COLLIN COUNTY, TEXAS

ADDENDUM No. One (1)

IFB NO. 2013-271

CONSTRUCTION, BRIDGE: COUNTY ROAD 419 OVER BRINLEE CREEK

COLLIN COUNTY, TEXAS
 COUNTY ROAD 419 OVER BRINLEE CREEK
 ROADWAY
 PLAN & PROFILE

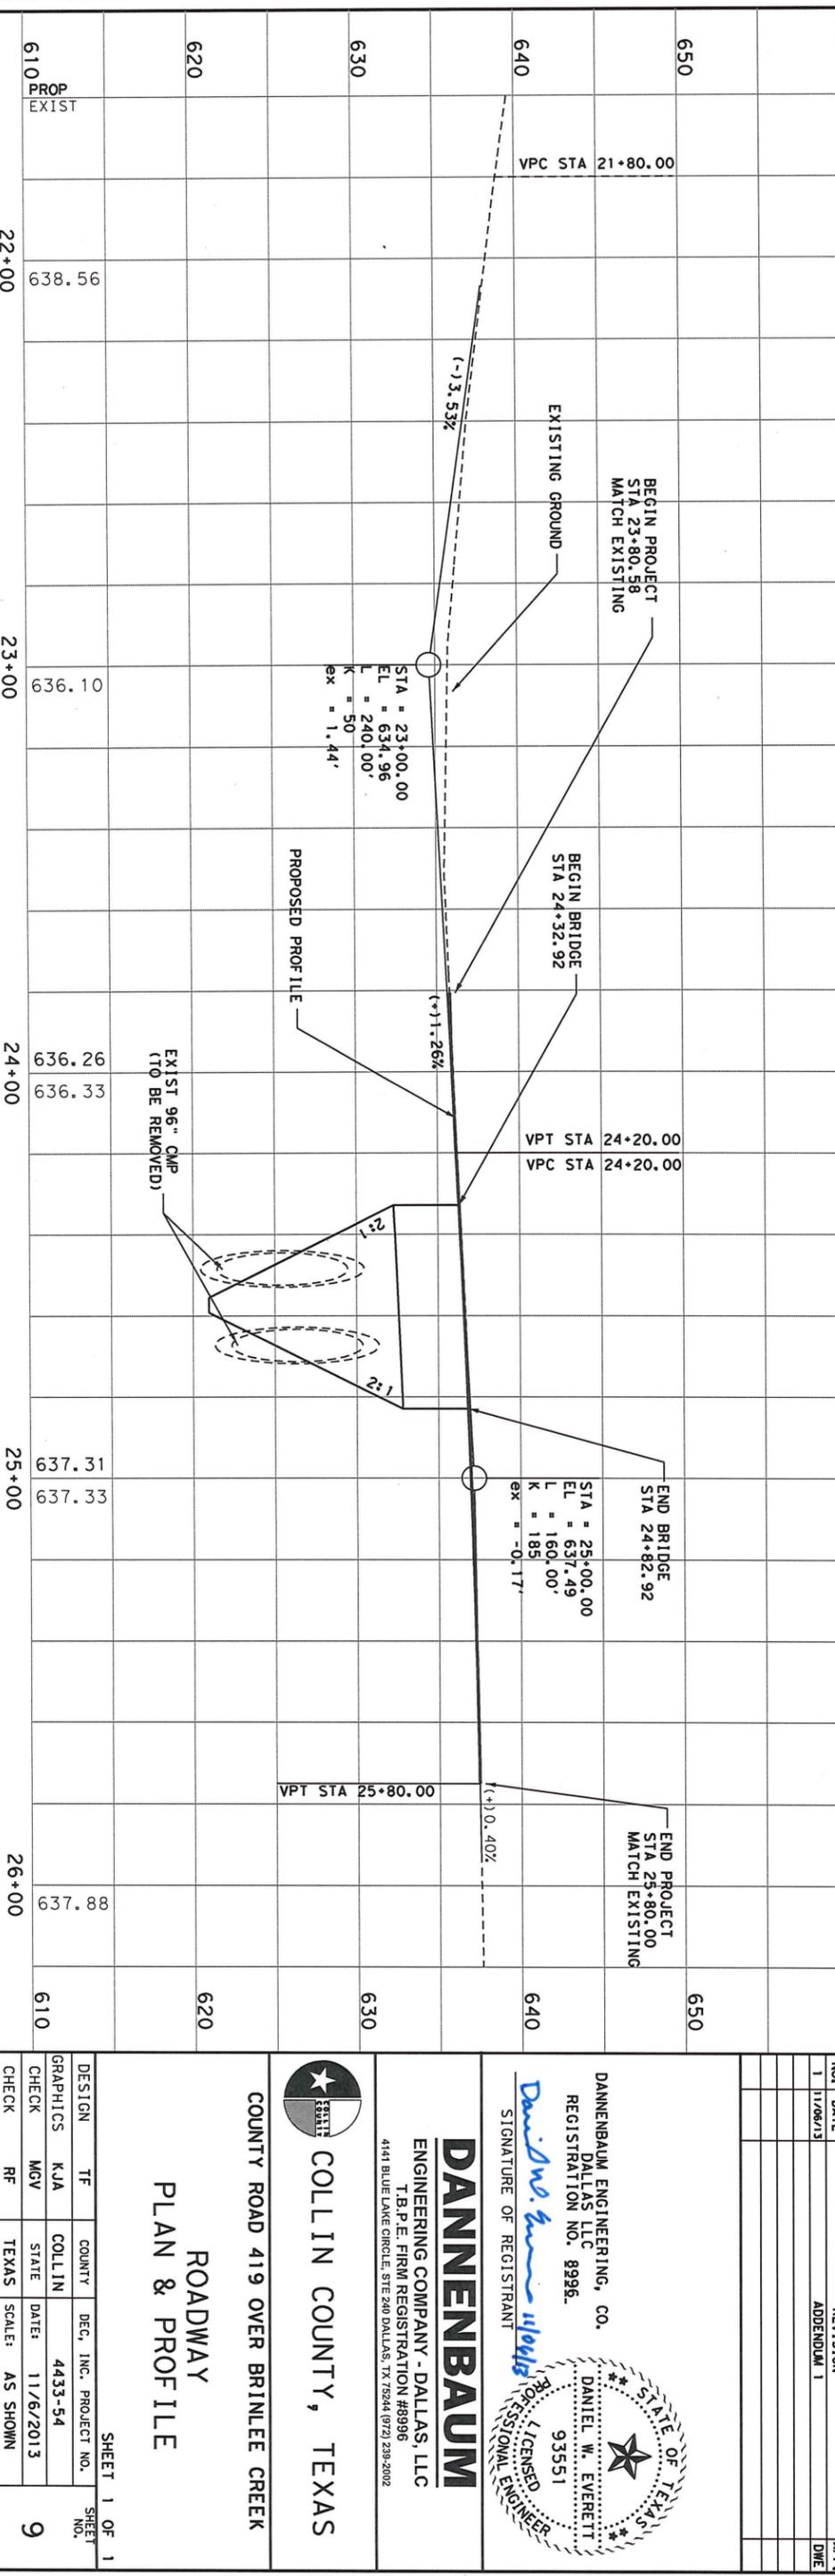
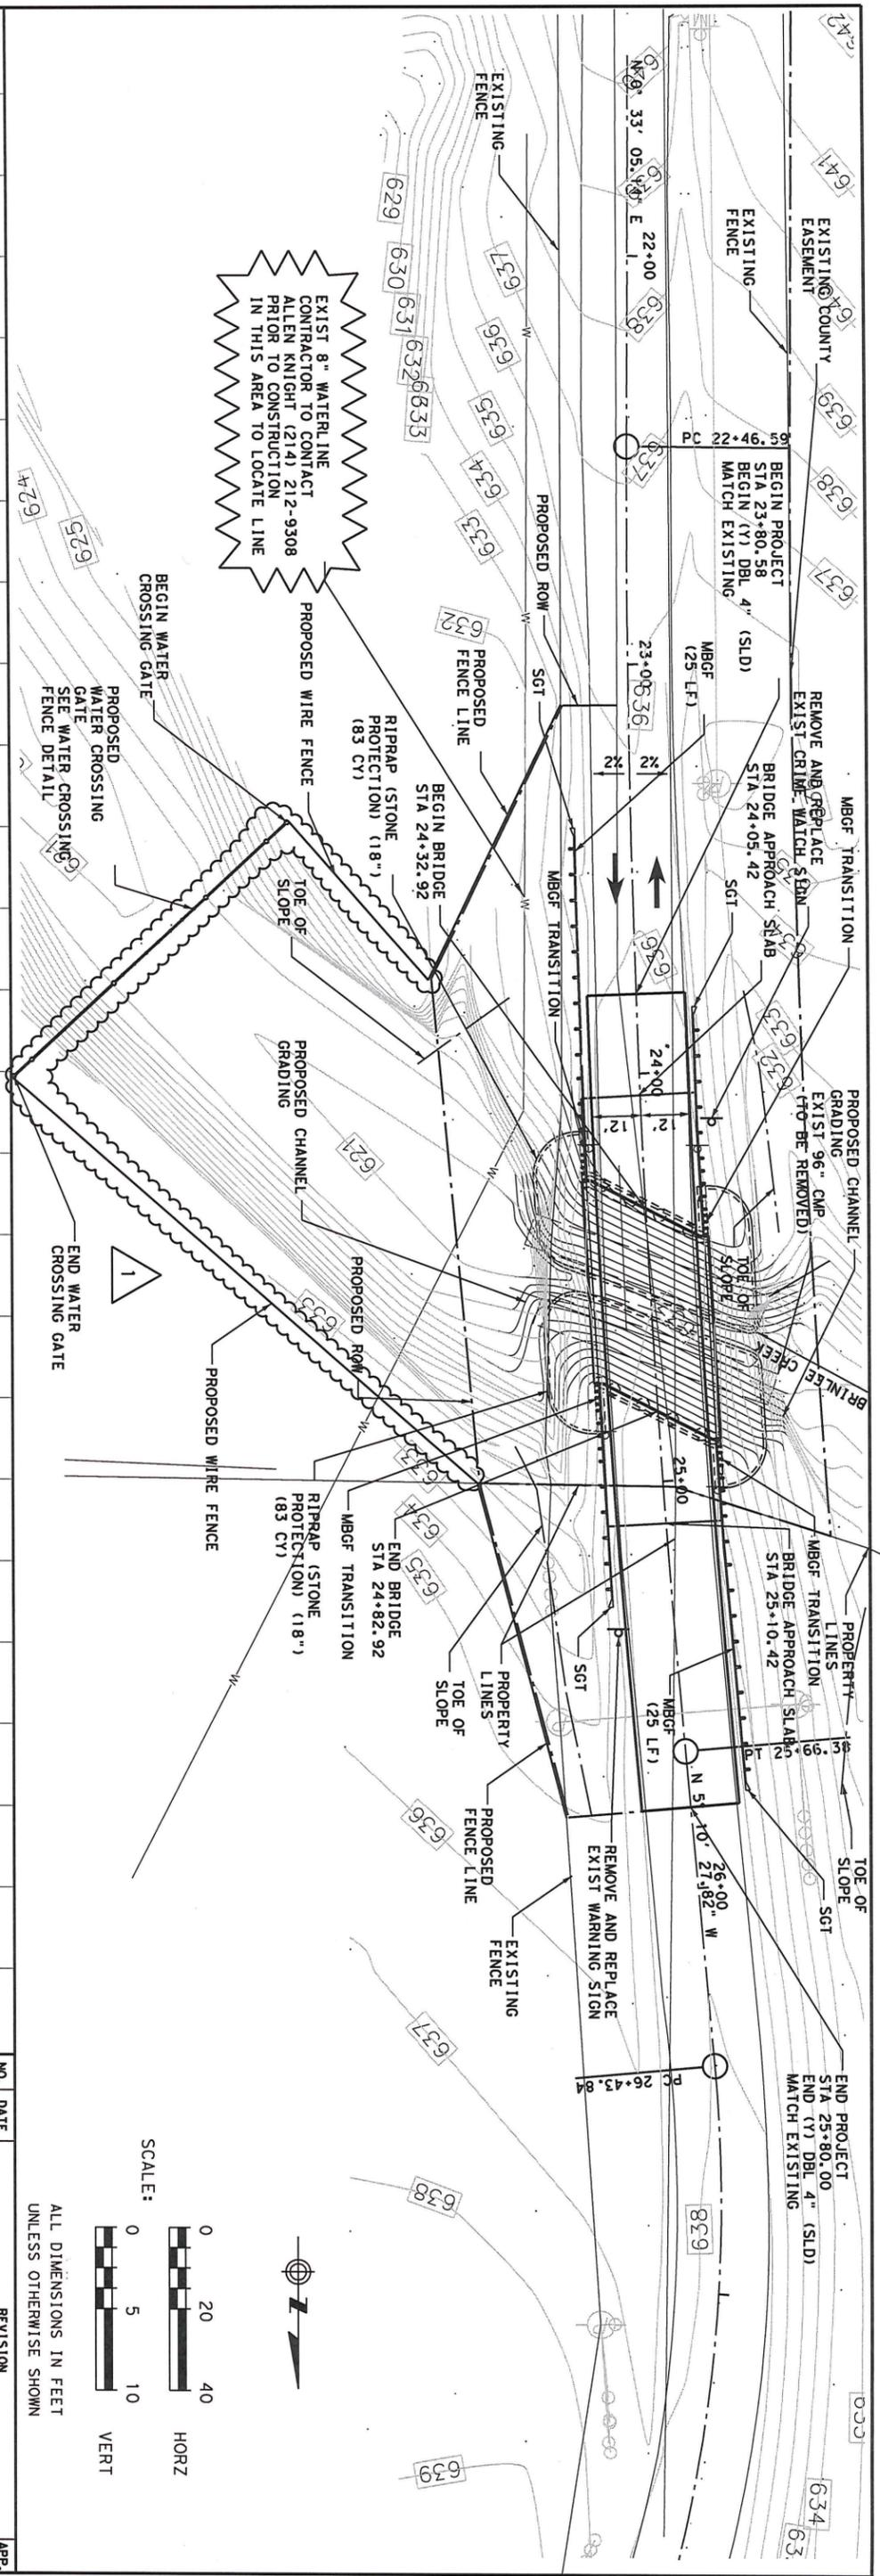
I don't see how 25 cy of embankment can be enough material to rebuild the slopes of the roadway as shown on sheets 9, 48, 49 & 50. Is this quantity correct? (Submitted: Nov 1, 2013 8:07:28 AM CDT)

- There will be 850 CY of excavation from the roadway channel for the grading of the bridge. We determined this material to be sufficient to rebuild the side slopes of the proposed roadway. (Answered: Nov 4, 2013 2:01:12 PM CST)

DESIGN	COUNTRY	DEC. INC. PROJECT NO.	SHEET NO.
GRAPHICS	COLLIN	4433-54	1
CHECK	STATE	DATE: 11/6/2013	2
CHECK	TEXAS	SCALE: AS SHOWN

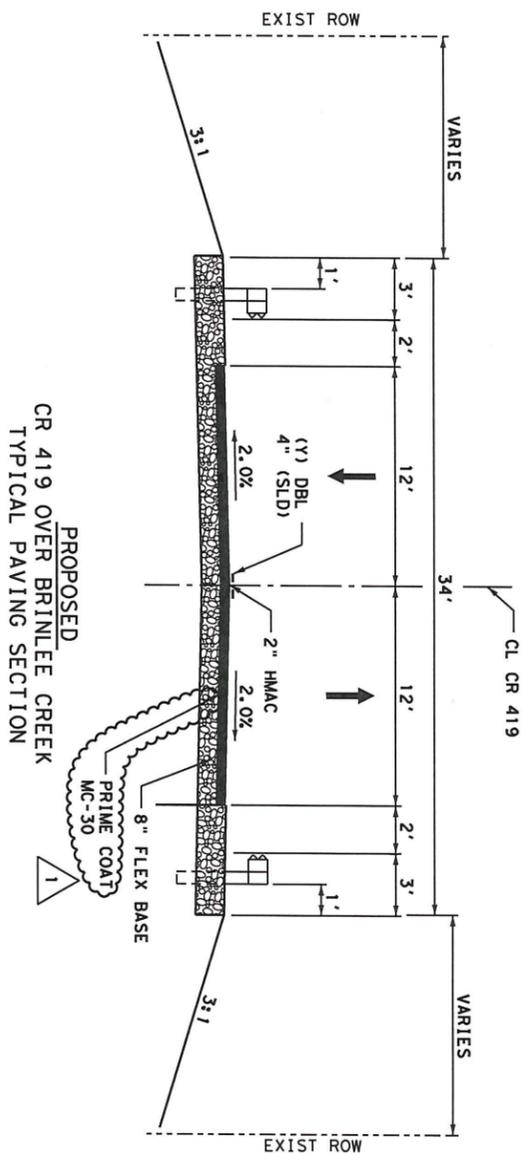
Sheets 9, 15, 48, 49 & 50 shows a need for excavation and embankment. The quantity for these items are not determined in the plans and there are no bid items for them. Will embankment and excavation be added to the bid items? (Submitted: Oct 28, 2013 10:24:22 AM CDT)

Sheet 2 and 16 do not have a bid item for approach slabs but sheets 15 and 20 indicates that approach slabs are included. Will a bid item be added for them? (Submitted: Oct 28, 2013 11:44:16 AM CDT)

- Excavation and Embankment quantities area accounted for and are noted in the estimated quantities on sheet 2. (Answered: Oct 29, 2013 2:14:42 PM CDT)

- Bid Item will be added for approach slab. (Answered: Oct 29, 2013 2:14:42 PM CDT)
